### **Safety Recall Notice 19V-659**

**SAFETY NOTICE**

**SN675**

**SUBJECT:** TL Upper Boom Cylinder Counterbalance Valve

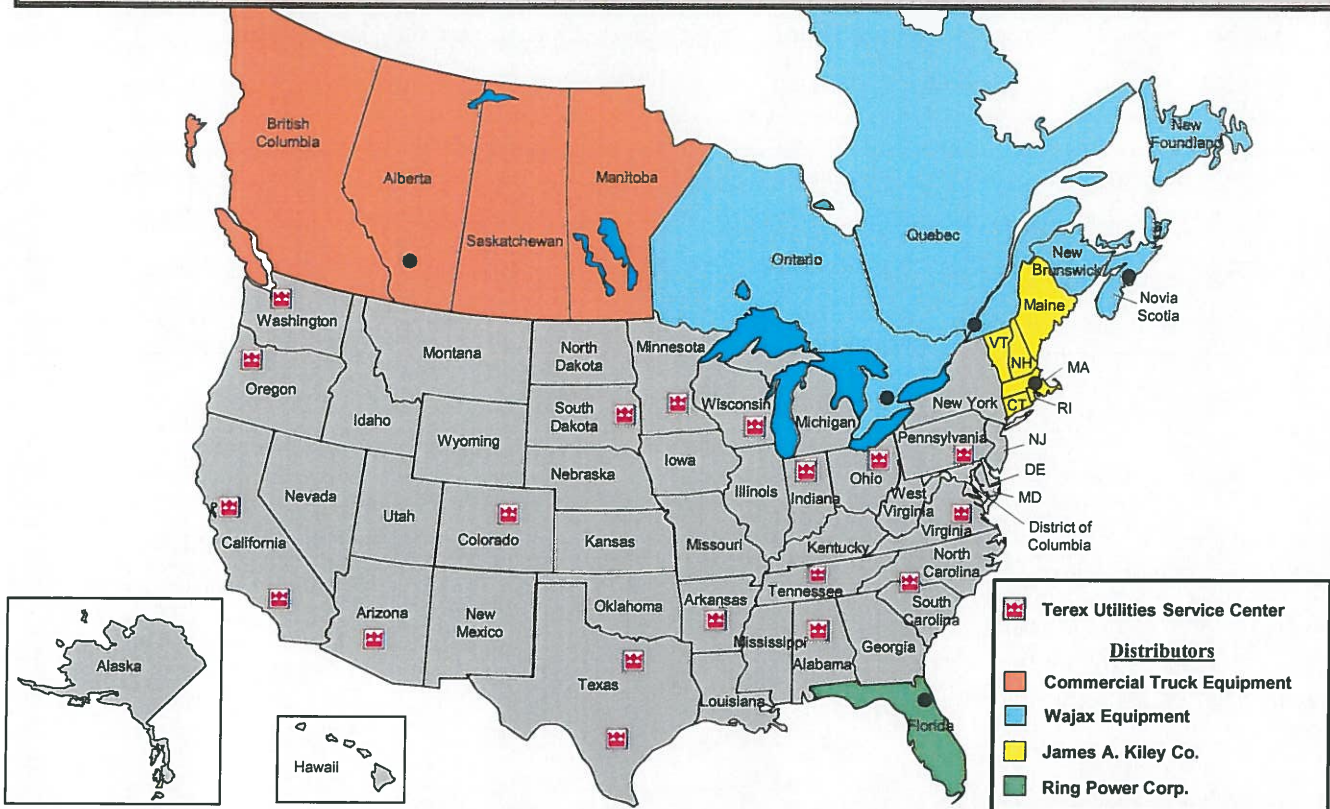
Immediately inspect the upper boom lift cylinder. If the cylinder matches the view below, look at the holding valve cartridge closest to the base end of the cylinder. If the marking is CBBA-2000 the valve needs to be replaced.

Only TL units built with the cylinders as shown in the view above are affected. If an owner contacts you call TEREX Utilities at 844-837-3948 and ask for the warranty department for instructions and to arrange shipment of parts.

Terex will replace holding valve cartridges determined to have the incorrect setting at no cost to the owner. Field Service kit Z1564 will be provided to the nearest Terex Utilities dealer or Field Service Technician for installation on your unit if it is subject to this recall.
